ETIHAD STADIUM NORTH STAND EXPANSION **NON-MATERIAL AMENDMENT SUMMARY**

26/07/2024

NSE-POP-ZZ-ZZ-TR-A-008112

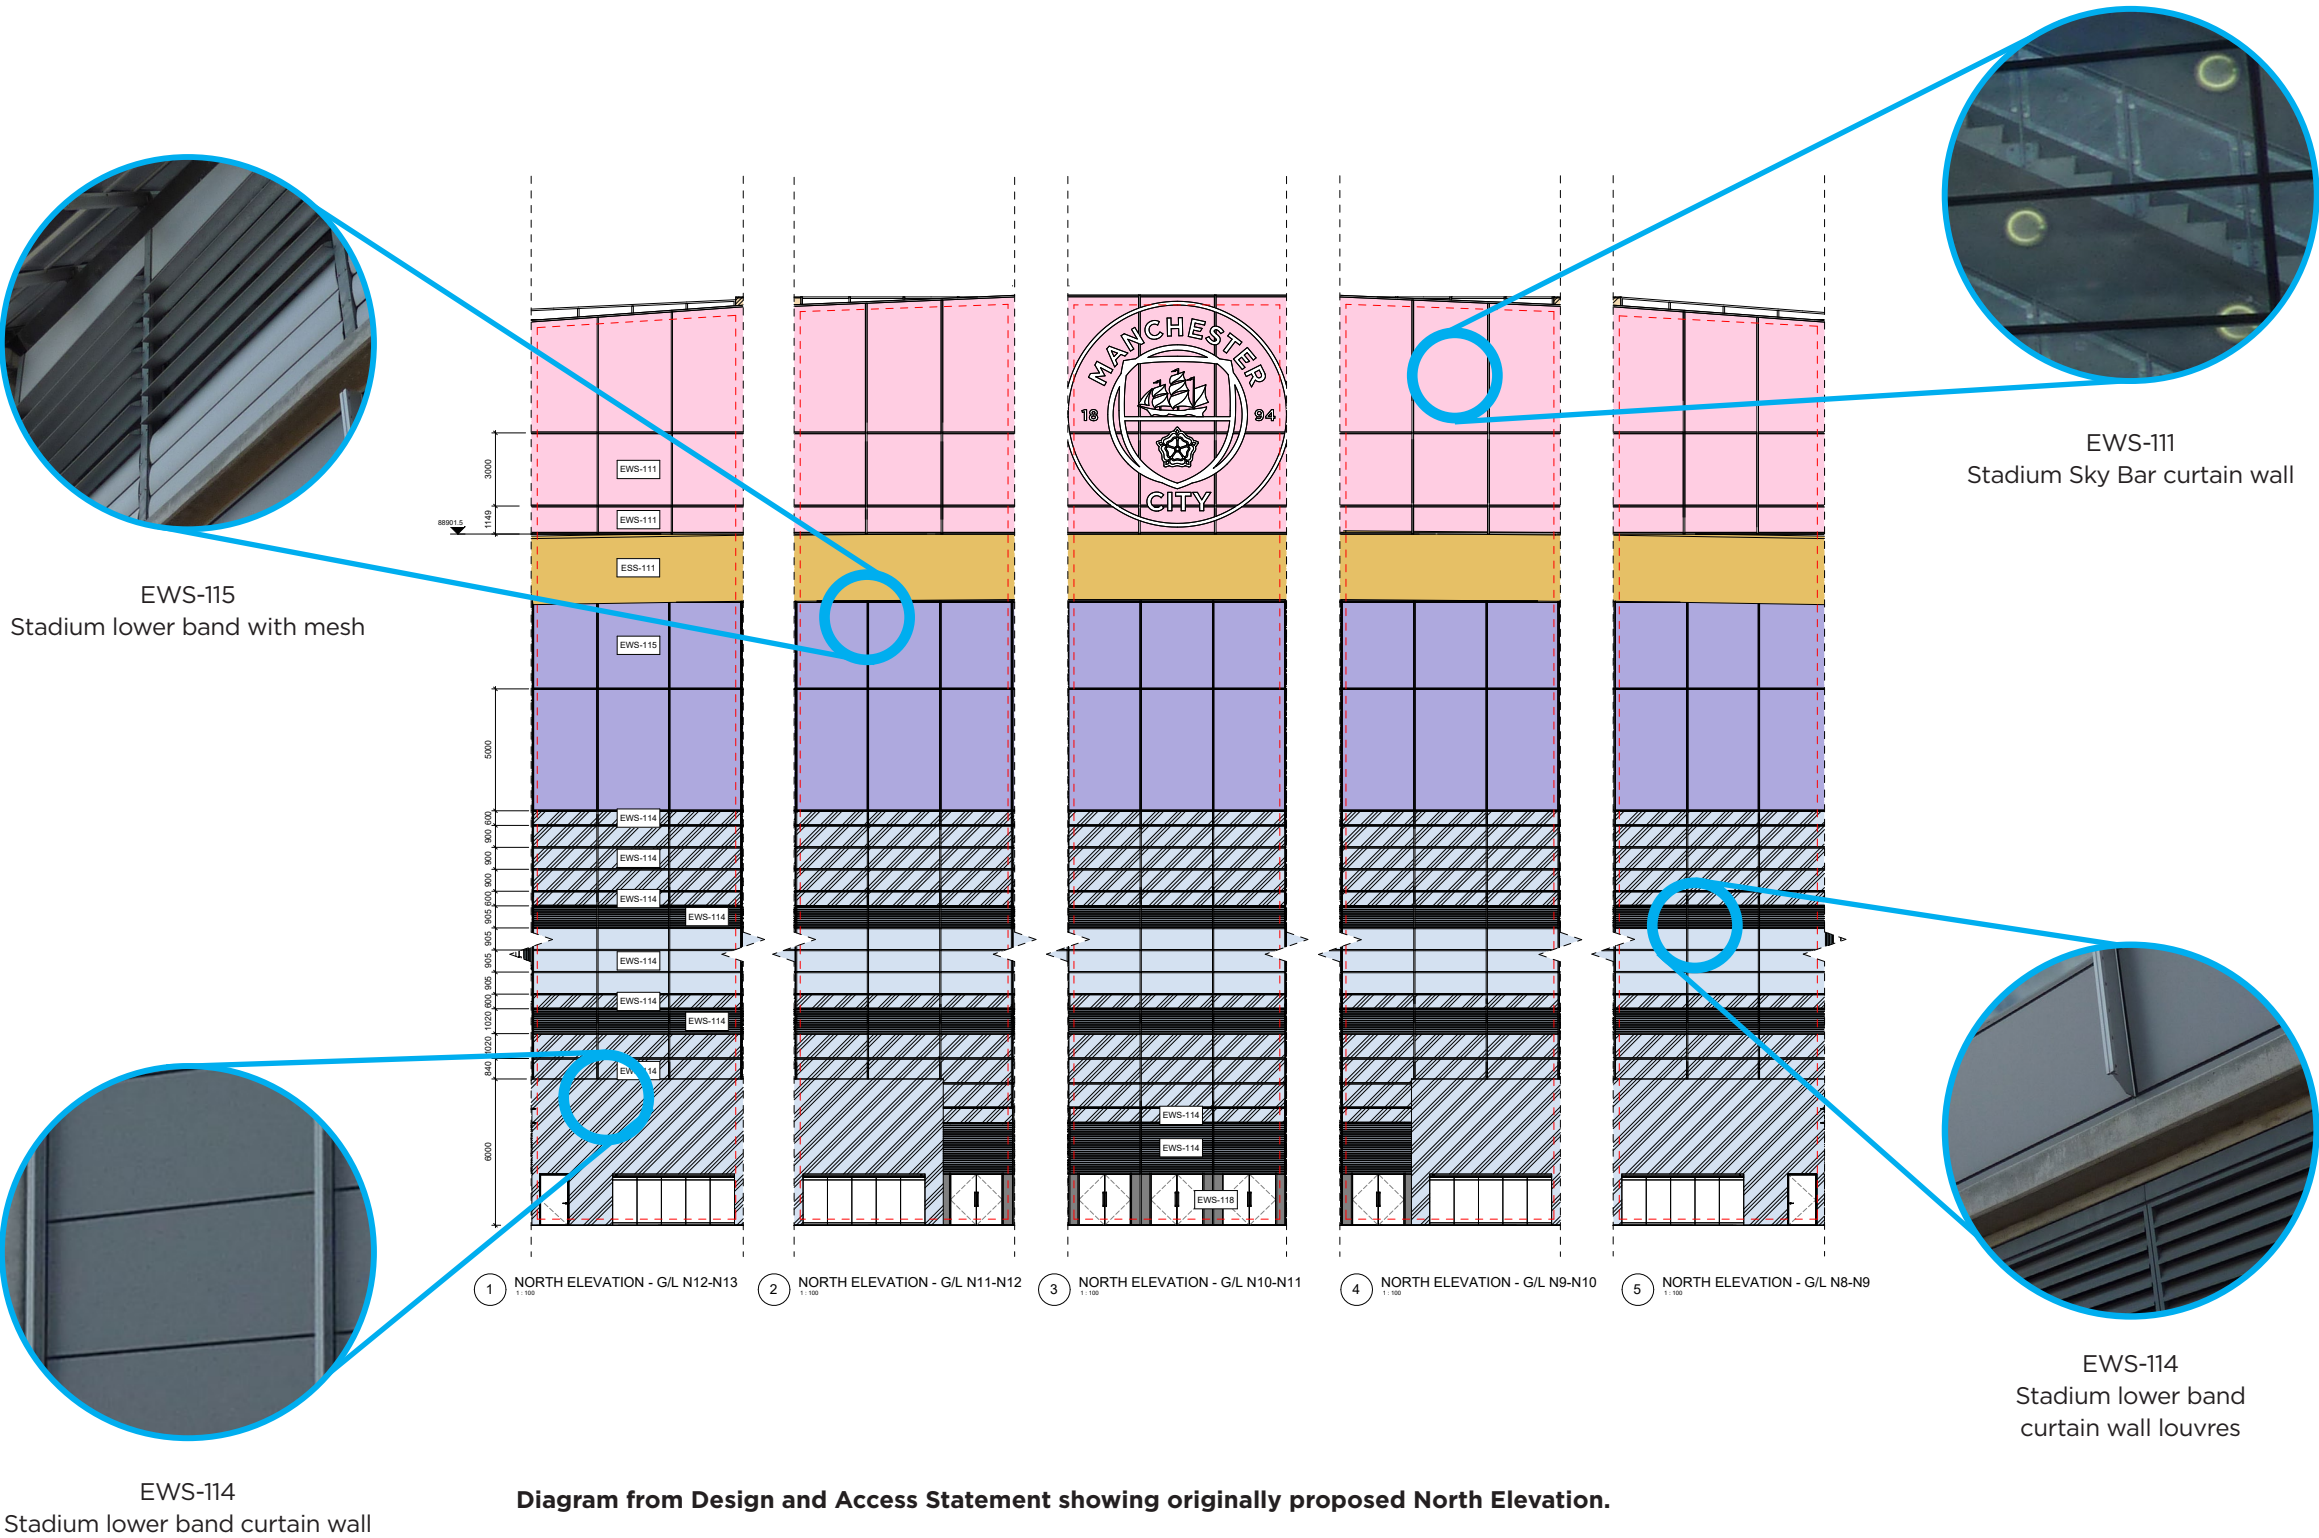
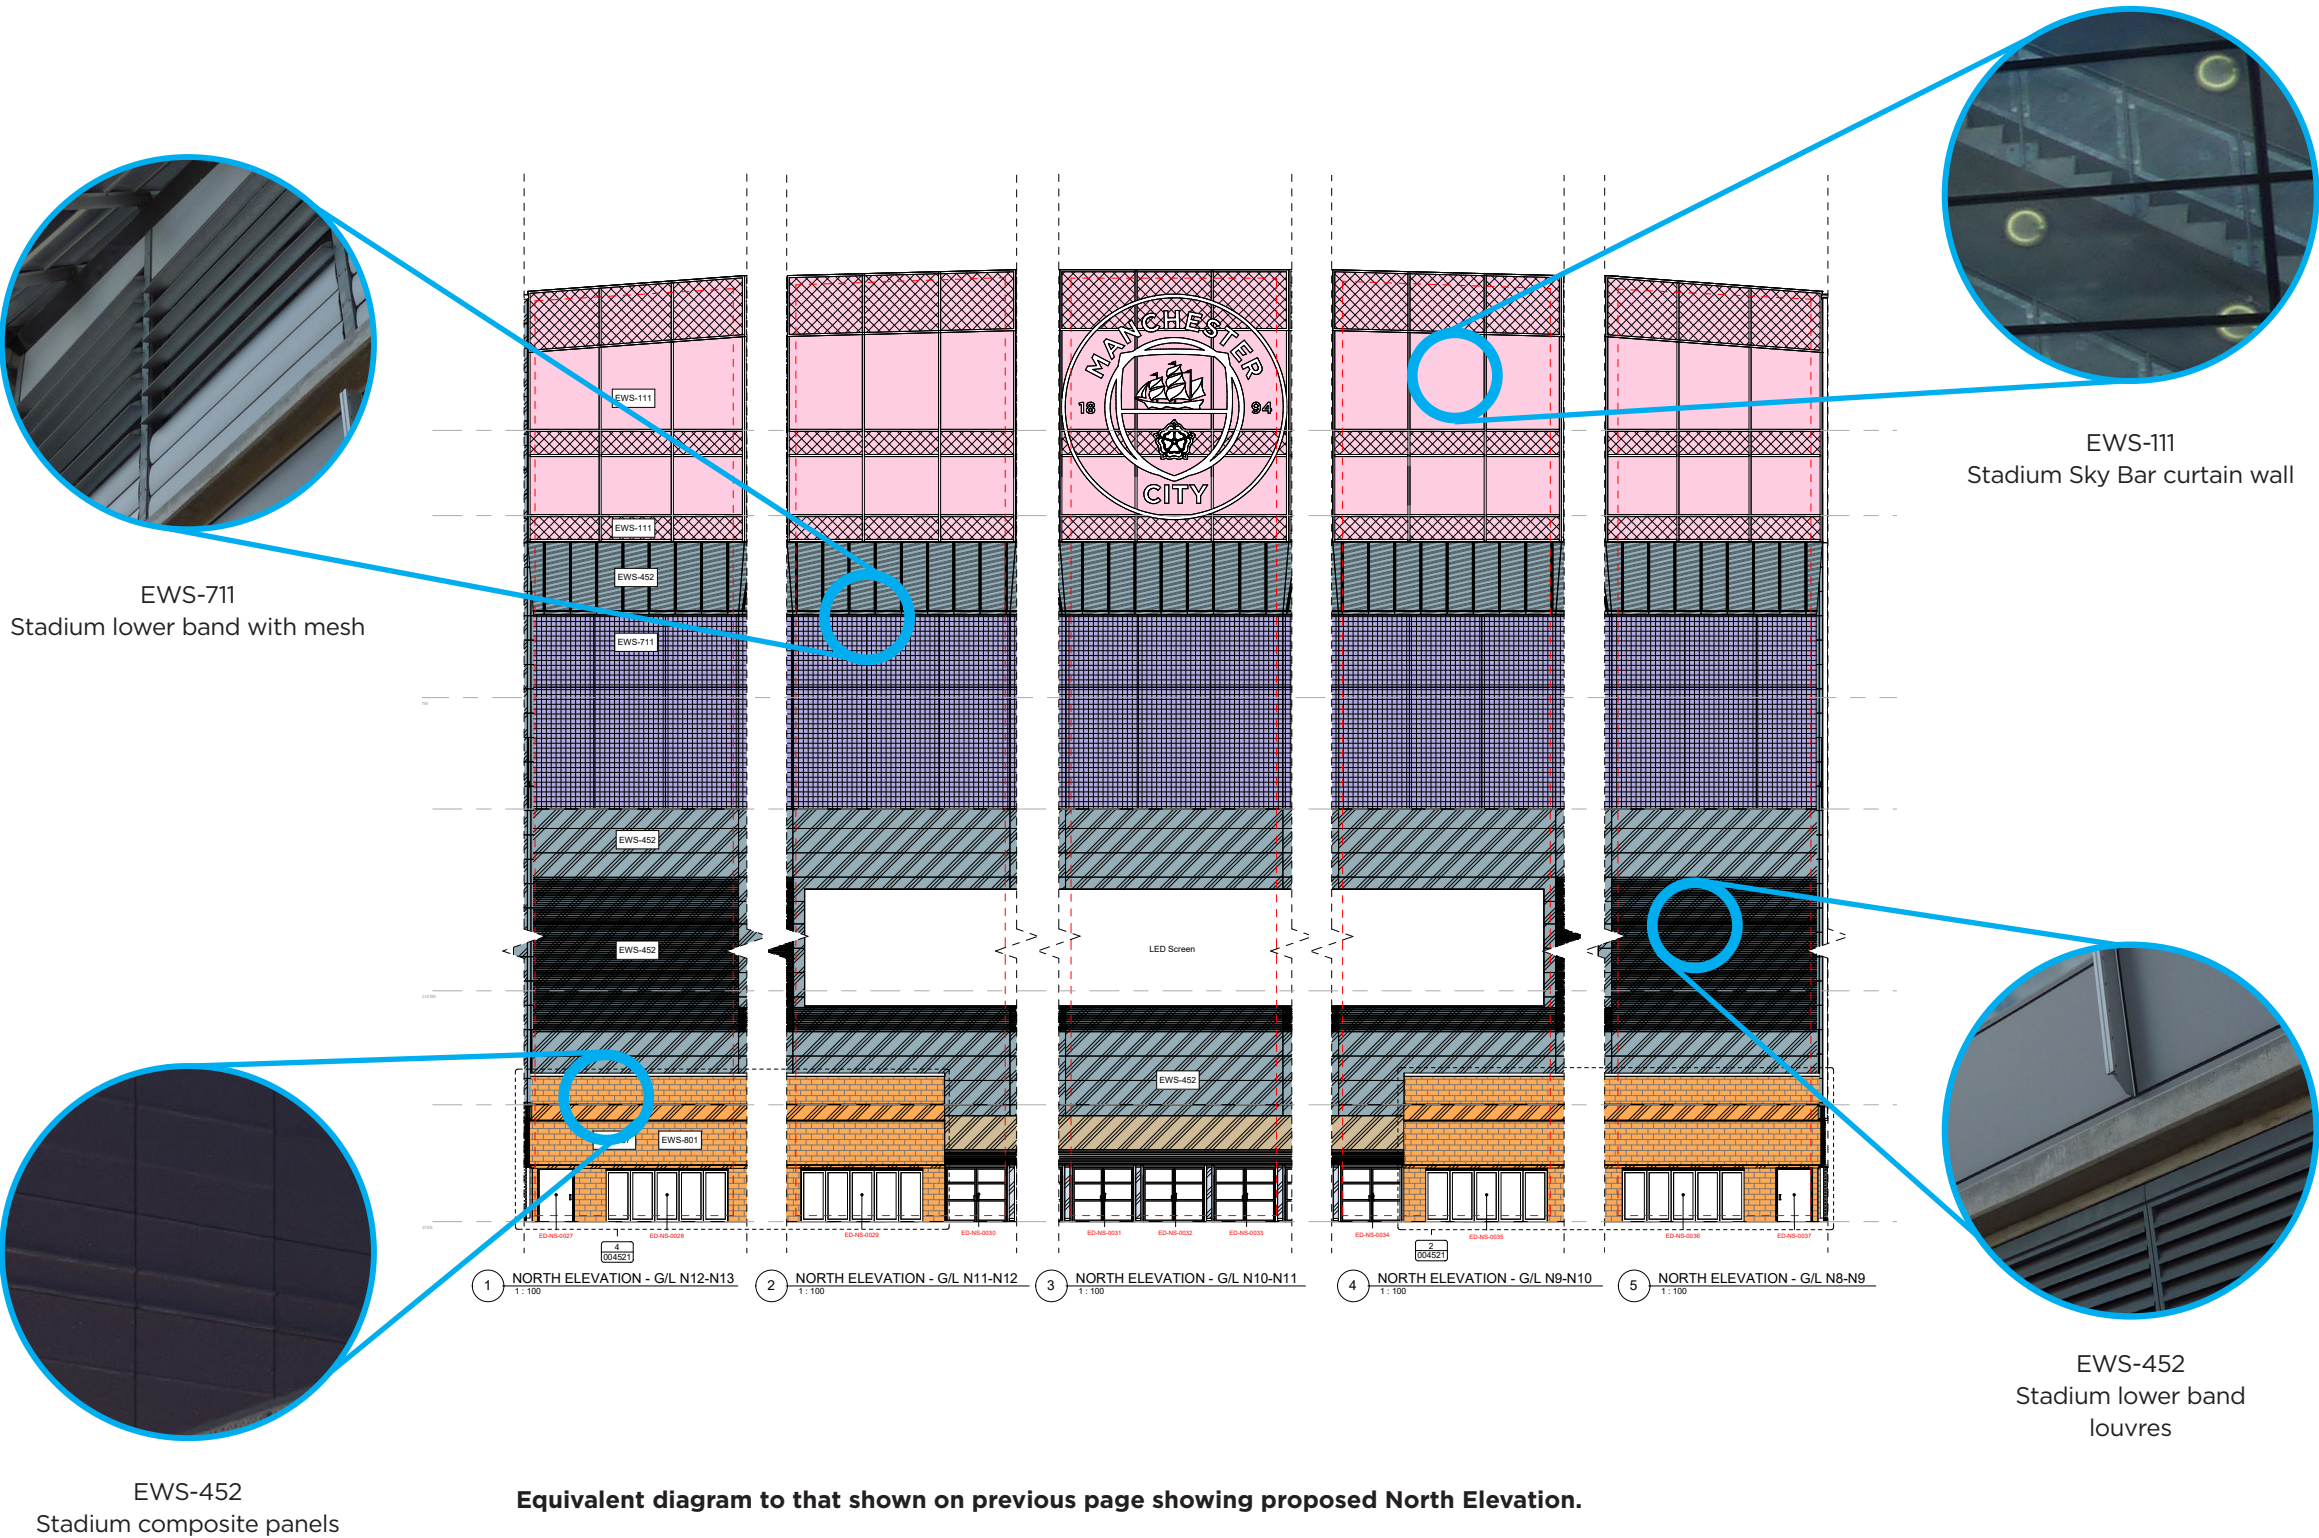
The proposed elevation relates more directly to the materiality of the circulation cores on each side, with composite panels the same orientation and width.

Integrated into the centre of the facade is a large LED screen, framed by louvres that allow the natural ventilation of the spaces behind.

The design of the remainder of the facade has been refined but is fundamentally unchanged. Note that whilst some of the External Wall System codes have changed, the descriptions (apart from the composite panels) have not.

Extract from drawing NSE-POP-NS-ZZ-DR-A-000301, showing an overall site North Elevation from the consented Planning Application.

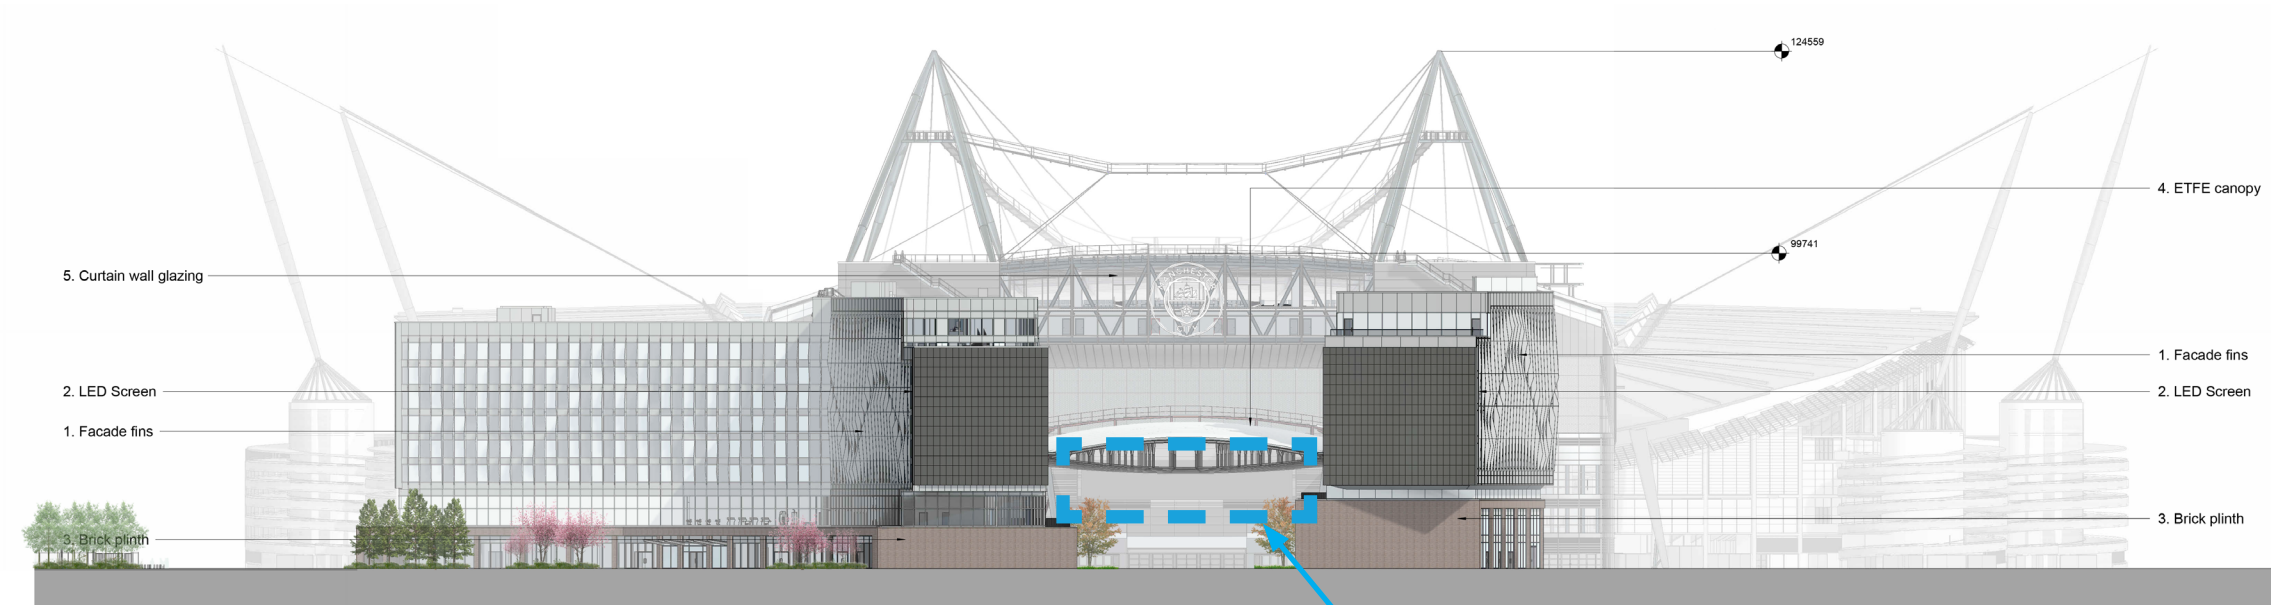
The adjacent drawing extracts show the very minor nature of the amendment in the context of the wider project.

The bigger screen can be seen in the lower image, albeit very sheltered by the City Square ETFE canopy and the neighbouring hotel and commercial buildings. The material change itself is almost imperceptible from outside of City Square.

Extract from proposed floor plan

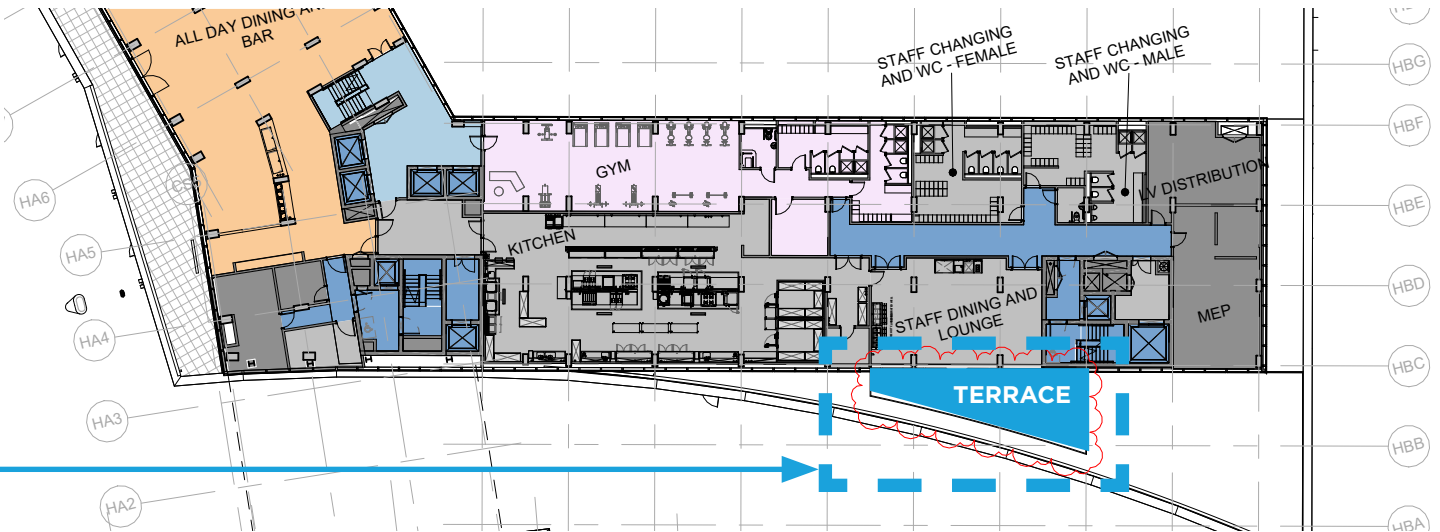
It is proposed to add a further terrace, in this instance facing south adjacent to the break space for hotel staff - providing

them with a private external space to enjoy their breaks away from event day crowds.

The railings that enclose this area have been deliberately pulled back from the edge of the roof to minimise disruption to the ground floor facade and make the terrace itself much more subtle.
